Report: TAB REPORT
Function: Test, Adjust, & Balance
Date: 02/05/2025
Completed By: National TAB

PROJECT
01-27-25 CAVA FISHERS, IN (116TH ST)

Project: 01-27-25 CAVA FISHERS, IN (116TH ST)

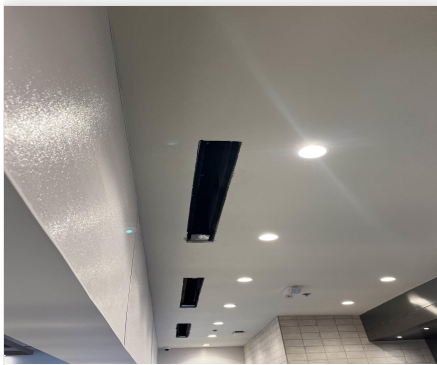
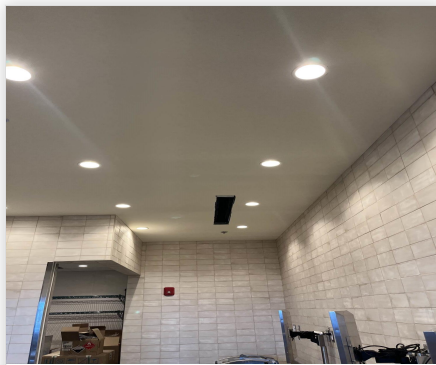
Issue Name : FCU1 missing linear grilles
Description : None of the linear grilles are installed on FCU1. These grilles will control the airflow to these diffusers so airflow cannot be set currently.
Created By : National TAB **Assigned To :** National TAB - Jacob Davidson
Status : Open
Priority : High **Asset Tag :**
Originated Date : 01/27/2025 - Jacob Davidson - National TAB

Asset: CEF1

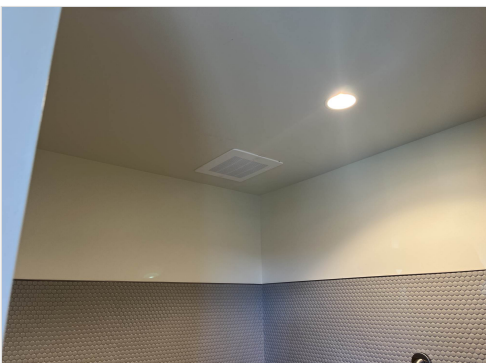
UNIT DOES NOT HAVE A SPEED CONTROLLER AND COULD ONLY BE SET TO HIGH OR LOW SPEED. AT LOW SPEED THE UNIT WAS ONLY READING 80CFM. OPTED TO GO FOR HIGH SPEED AS THAT WILL KEEP THE SPACE NEGATIVE.
